Upper Brook Street, Masterplan
(Williams Motor Co (Holdings) / Alliance
UBS Limited)

Planning Ref: 137401/FO/2023

**Improvements to Junction of
Upper Brook Street / Booth
Street East / Inchley Road**

**Highways Technical
Note 05**

The following joint authorisations indicate both parts are in agreement with the RSA actions detailed within the above RSA decision log.

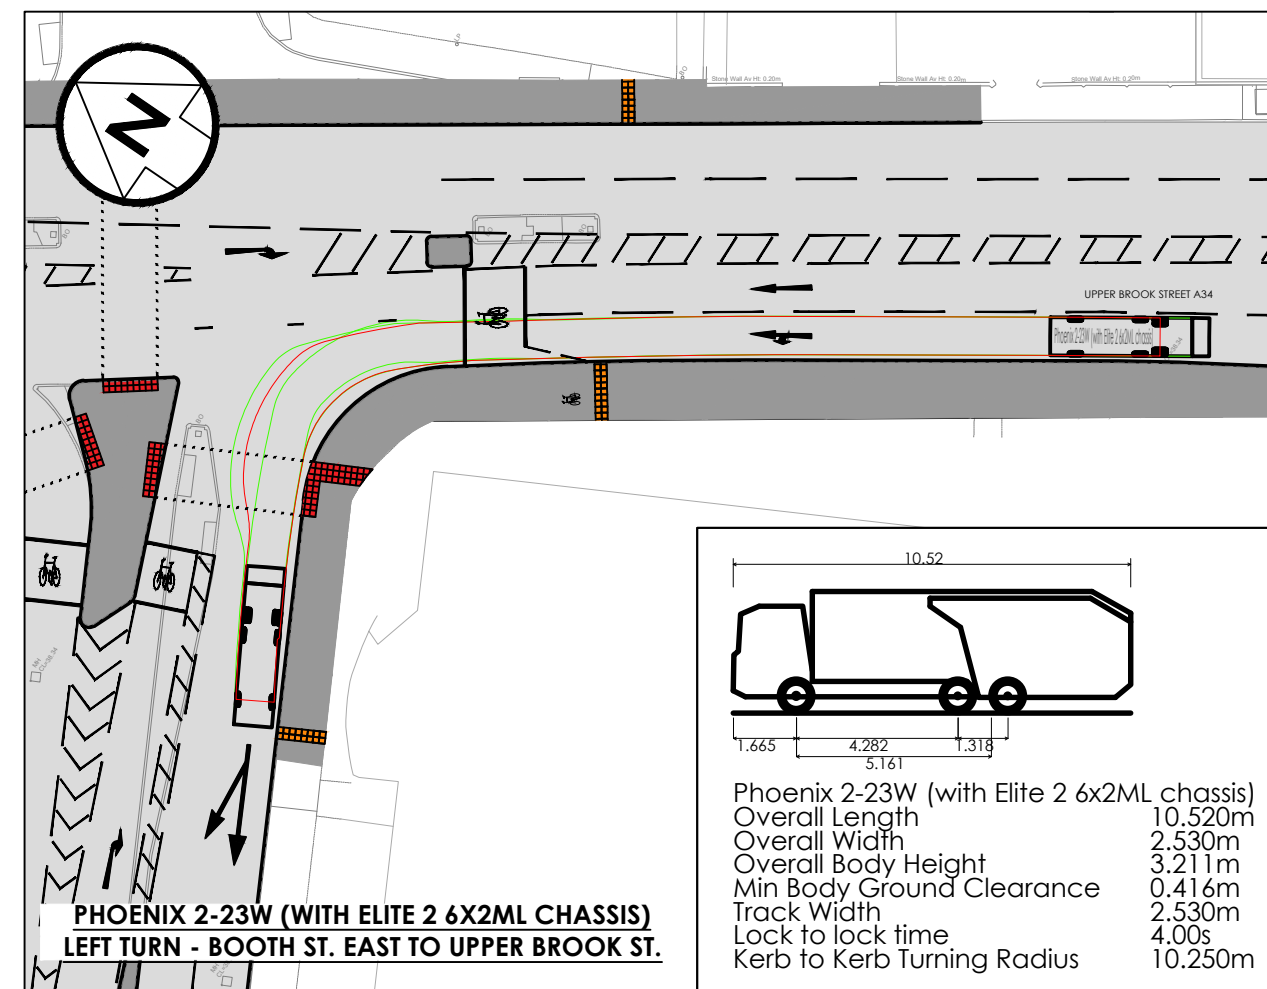
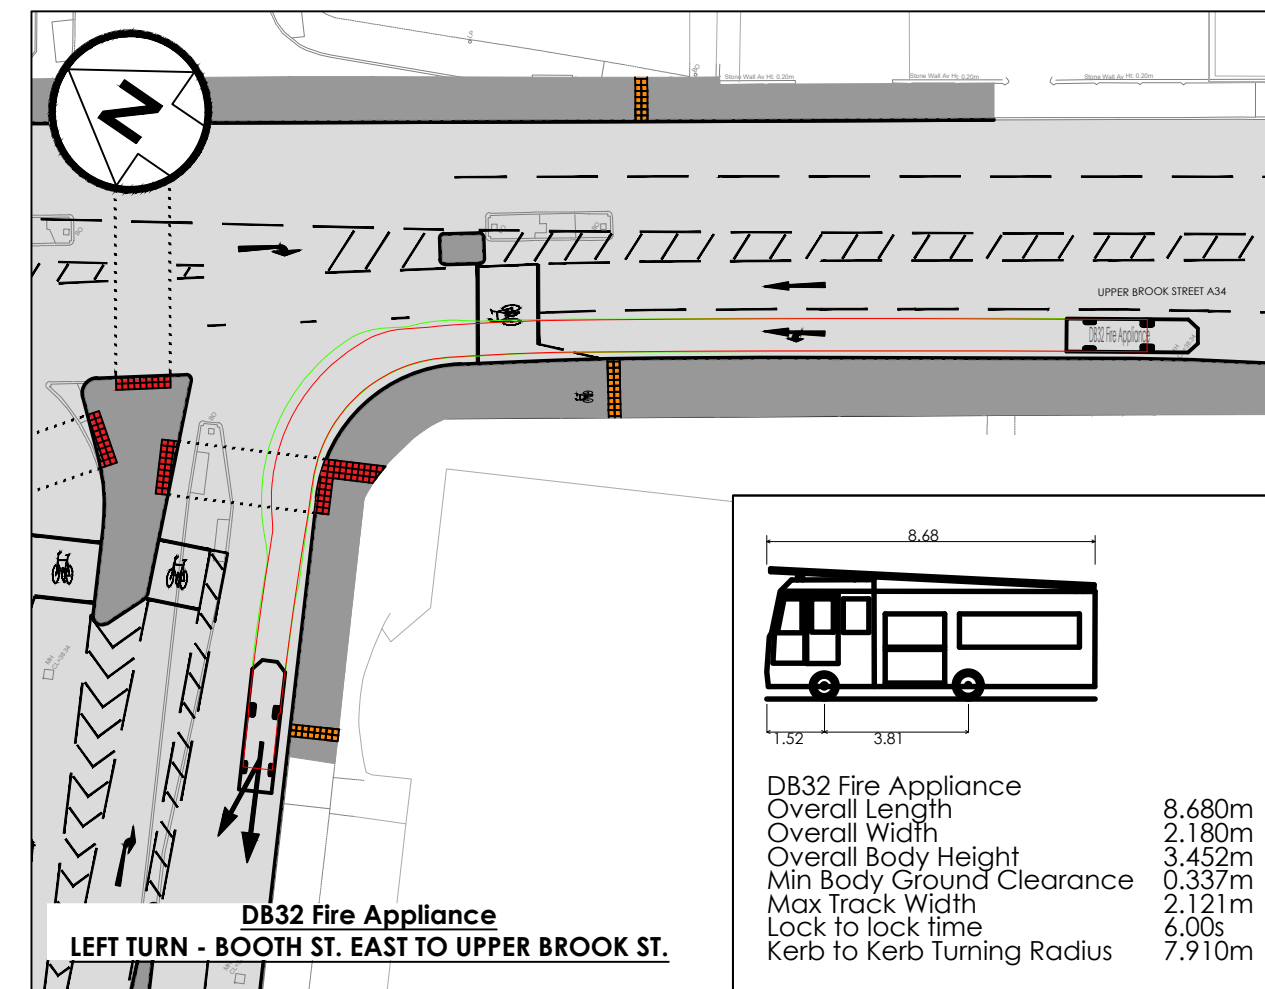
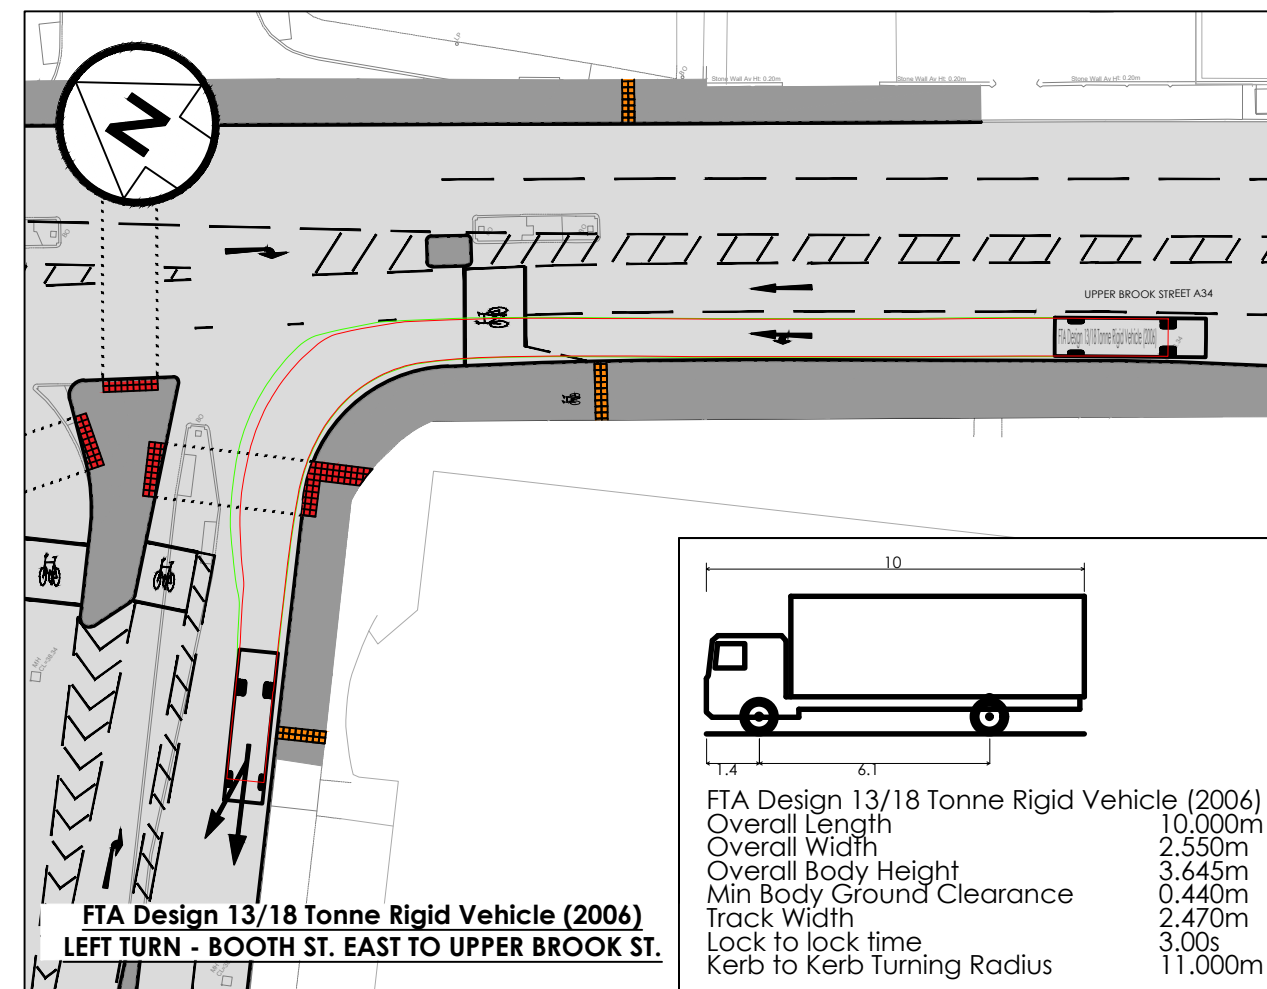
RSA problem		RSA recommendation	Design organisation response	Overseeing Organisation response	Agreed RSA action
3.1.1	<u>LOCATION:</u> Booth Street East <u>SUMMARY:</u> Alignment could result in conflicts It is proposed to realign the approach arrangement to the junction whereby forming a large splitter island between the left and right turns but omitting the existing offside splitter island which currently segregates north and southbound traffic. Concern is expressed that the proposed alignment is unusual in its formation whereby traffic turning right out of Booth Street East have a nearside island but nothing to protect on the offside from traffic turning into the side road as is the current situation. Not only is there a risk of driver confusion as to the proposed road layout, such an arrangement increases the risk of head-on type conflicts between traffic turning right out of the side road and traffic turning into it	An alternative layout should be investigated, for example repositioning the splitter island to the offside of the right turn lane and keeping the left and right turn traffic lanes together.	Response: Partially Accepted Given available highway constraints to the junction it is not possible to incorporate an additional splitter island on Booth Street East of sufficient size to safely accommodate an active travel user (ATU) refuge. A range of junction options were considered at a stakeholder design workshop session and the principles of the current arrangement were identified as providing the best opportunity to deliver enhanced ATU crossing facilities within junction land constraints. The layout of adjacent opposing traffic streams at a side road approach to a junction is similar in nature to other recently delivered schemes elsewhere within the city centre as part of ATU related improvement works. Variations considered at the workshop stage did include for the potential to reduce the size of the central splitter in order to reduce the extent of 'deflection' around the island for approaching traffic and potentially allow for the provision of a narrow traffic signal island (at circa 1.8m) between the opposing traffic streams. Such an option was ultimately rejected on the grounds that:	MCC/TfGM Response

3.1.2	<u>LOCATION</u>: A34 northbound through the junction <u>SUMMARY</u>: Through alignments could result in conflicts The northbound through alignment is	The alignments should be adjusted as not to cause conflict between lane 1 and lane 2.	Response: Accepted The comments from the audit team are accepted. The design team have reviewed the layout of the Upper Brook Street northbound approach and have revised the alignment through	MCC/TfGM Response

3.1.3	<u>LOCATION:</u> A34 northbound <u>SUMMARY:</u> Insufficient capacity could result in conflicts It is unclear as to whether removing one of the existing 3 northbound through lanes will significantly affect junction or link capacity causing congestion and increasing the potential for sudden braking or weaving type conflicts throughout	A review of the traffic model should be undertaken to ensure that the junction and link operate within capacity	Response: Accepted The removal of one of the three northbound lanes to UBS is not predicted to result in capacity or congestion issues. In practice, the part of the approach section of Upper Brook Street to the south of the junction already operates as a two-lane approach and only widens to three lanes approximately 130m to the south. Removal of this additional lane will therefore not result in additional weaving issues as there will be no requirement to change lanes as a result of the new arrangements.	MCC/TfGM Response

3.1.4	<u>LOCATION:</u> A34 approaches <u>SUMMARY:</u> Insufficient through lane widths 3m-3.2m wide traffic lanes have	Through traffic lane widths should be suitably increased.	Response: Rejected The proposed lane widths to Upper Brook Street are based on the lane dimensions currently in day-to-day use at the junction.	MCC/TfGM Response

the following amendments (see 766-042-WCL-009 - 012 (P03) General Arrangement (Option 3)): - Slight narrowing and re-shaping of the central splitter island to reduce perceived extent of deflection for the right turn lane around the island and to better align this lane in relation to the entry lane from Upper Brook Street. - Introduction of additional road markings to deliver an area of hatched segregation between the two lanes and to guide turning traffic into Booth Street East to follow a suitable alignment. Vehicle swept path testing of the layout as illustrated in drawing 766-042-WCL-024 (P02) demonstrates that all vehicle turning movements can be wholly accommodated within the amended marked Booth Street East entry lane with the articulated lorry showing the worst case swept path. In practice the Nov 2022 traffic surveys identified that large HGV traffic (OGV2) represented only 0.3% of all left turn traffic movements from Upper Brook Street to Booth Street East for the core daytime 12hr period (07:00-19:00).

such that lane 1 traffic is deflected to the offside due to the cycle facility widening and a similar point, lane 2 traffic is deflected to the nearside to accommodate the opposing right turn pocket. This arrangement could increase the potential for side swipe type conflicts between lane 1 and lane 2 traffic within the junction.		the junction as illustrated in drawings (766-042-WCL-009 - 012 (P03) General Arrangement (Option 3)) This amended alignment involves the extension of the proposed section of footway widening to the westbound side of upper Brook Street (S) to provide a longer, straighter 2 * 3.2m lane approach to the junction stopline. This arrangement addresses the identified issue of consecutive nearside and offside lane deflection and therefore reduces the potential for side-swipe incidents. Additional road markings to Diagram 1005 have also been provided along the centre line of the northbound carriageway to guide vehicles across the junction more effectively. Revised swept path assessment illustrating relevant through vehicle & turning movements is included in drawing 766-042-WCL-024 (P02).

been proposed for the through traffic lanes. Given this is a bus route and used by large HGVs, concern is expressed that 3m-3.2m wide traffic lanes are insufficient and could encourage encroachment into the adjacent traffic lanes lane risking conflicts with adjacent vehicles.		The proposed arrangements do not result in any material reduction in road space. Due the surrounding land constraints it is not possible to deliver a practical increase in junction dimensions. By way of demonstration, drawing 766-042-WCL-SK-001 Existing Lane Widths, to this report illustrates existing Upper Brook Street approach lane dimensions. This exercise illustrates the following prevailing road widths: Upper Brook Street (N) Approach: 2 * 3.1m lanes Upper Brook Street (S) Approach: 2 * 3.1m lanes, 1 * 2.85m lane. The proposed junction scheme identifies the following provision: Upper Brook Street (N) Approach: 1 * 3.2m lane, 1 * 3.0m lane, 1 * 2.9m lane Upper Brook Street (S) Approach: 2 * 3.2m lanes. To reflect potential for greater use by bus / HGV traffic, the proposed junction improvement scheme includes for 3.2m lane widths to the nearside lanes to both Upper Brook Street approaches. It is ultimately concluded that the proposed lane width dimensions are realistic and appropriate for the location, based on prevailing conditions.
